PIC24FJ256GA705 FAMILY

PIC24FJ256GA705 Family Silicon Errata and Data Sheet Clarification

Data Sheet Clarifications

FIGURE 26-1: COMPARATOR VOLTAGE REFERENCE BLOCK DIAGRAM

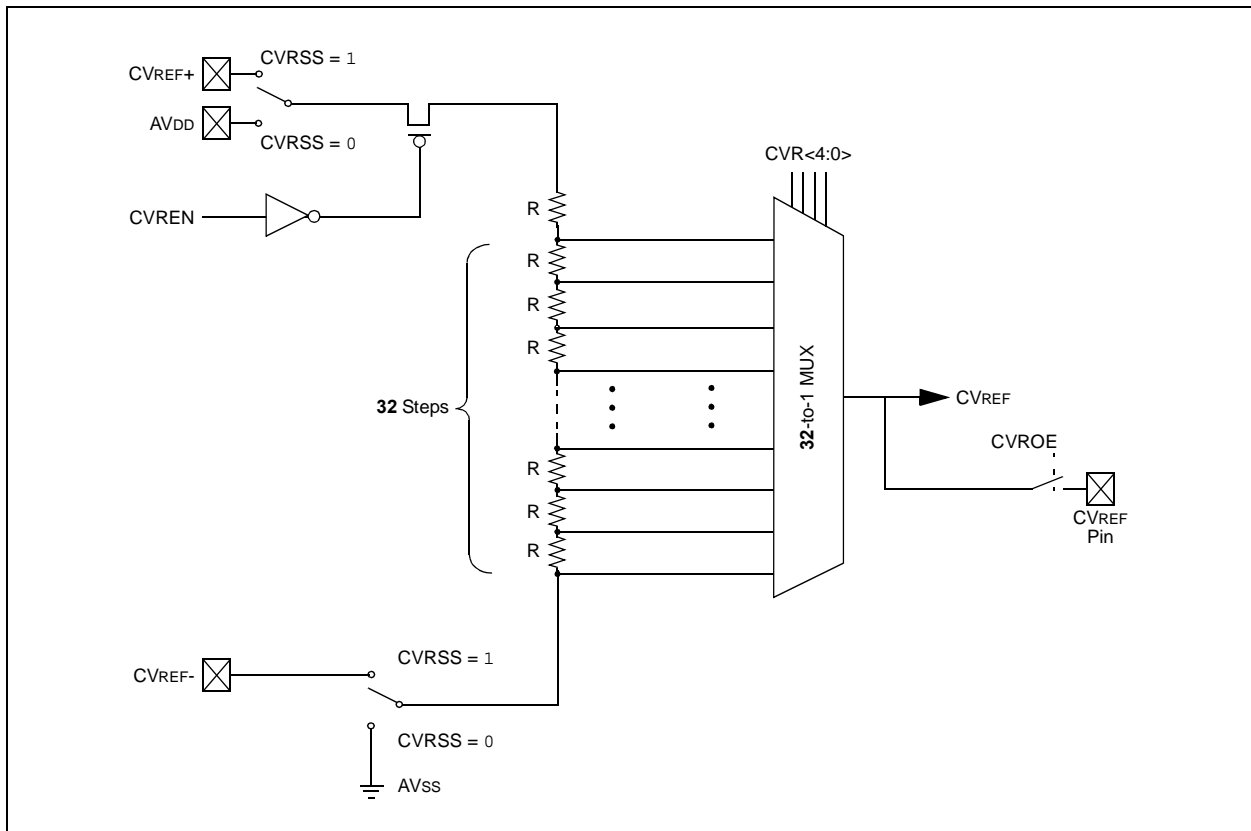
All voltage references have been corrected to 32 distinct voltage levels. In [Figure 26-1](#), the values for the CVR voltage levels have been corrected. The corrected values are shown in **bold**.

FIGURE 28-1: HIGH/LOW-VOLTAGE DETECT (HLVD) MODULE BLOCK DIAGRAM

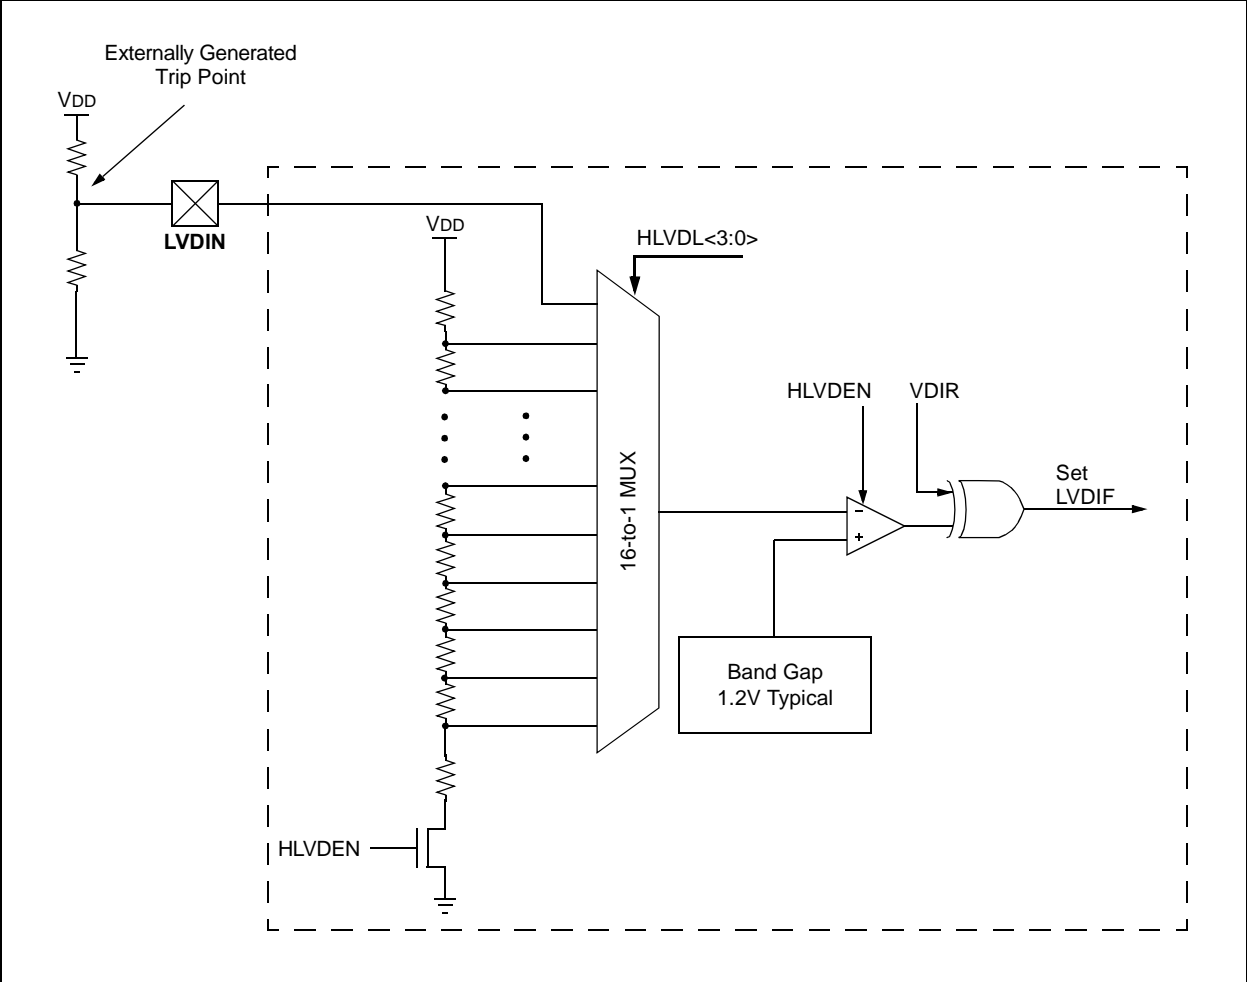
Figure 28-1 has been corrected with the proper voltage information. The corrected text is shown in bold>.

28-Lead Plastic Ultra Thin Quad Flat, No Lead Package (MV) – 4x4x0.5 mm Body [UQFN]

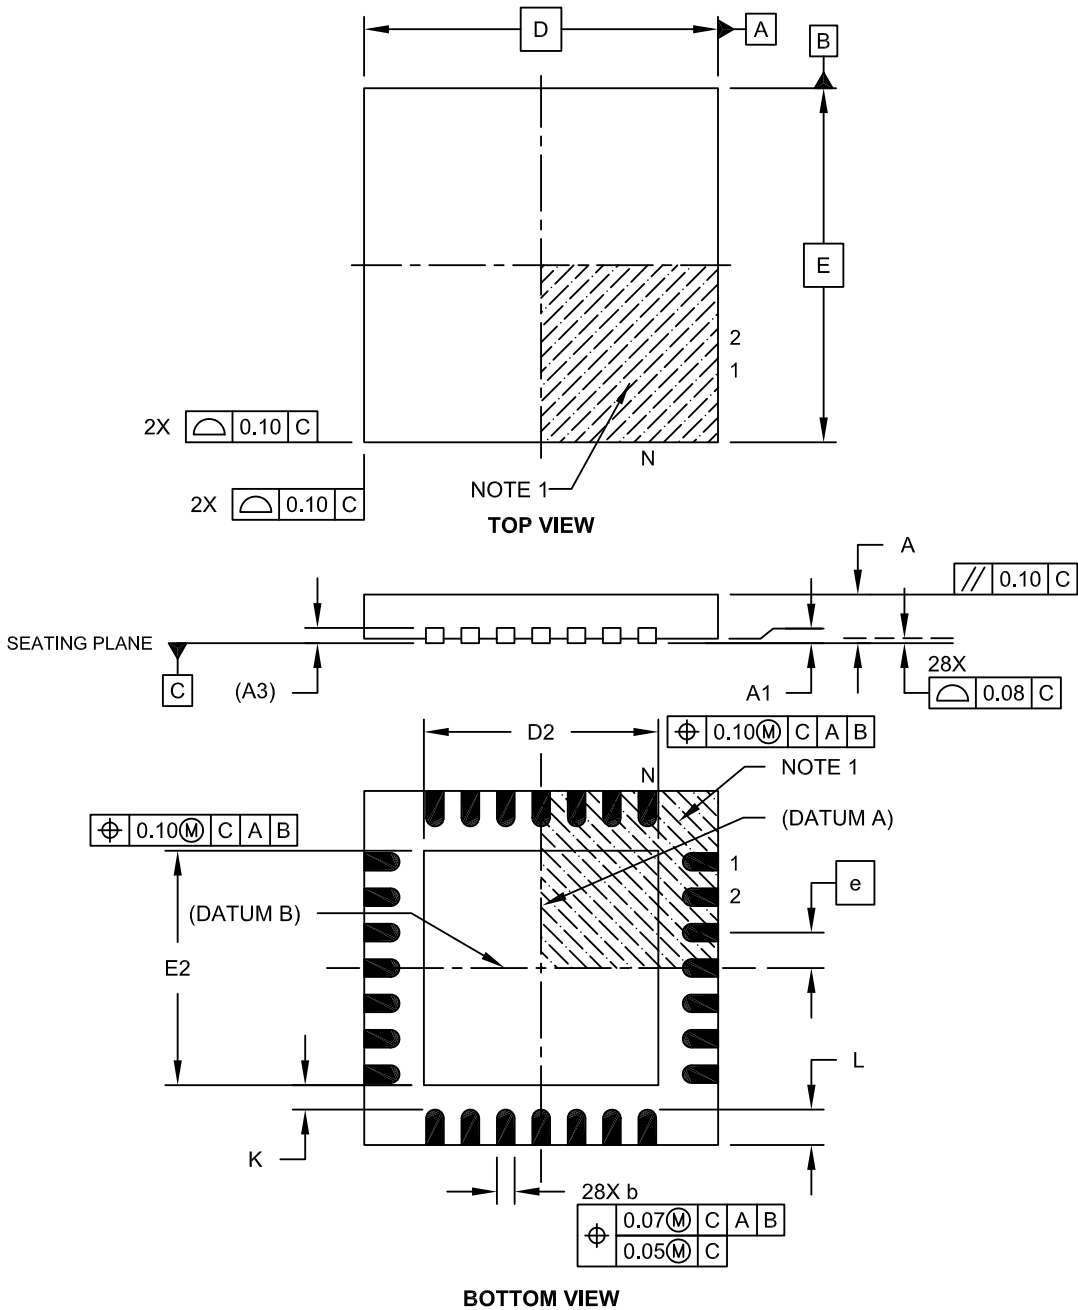
Replaced the 28-Lead M6 package drawings with the correct MV package drawings as shown below.
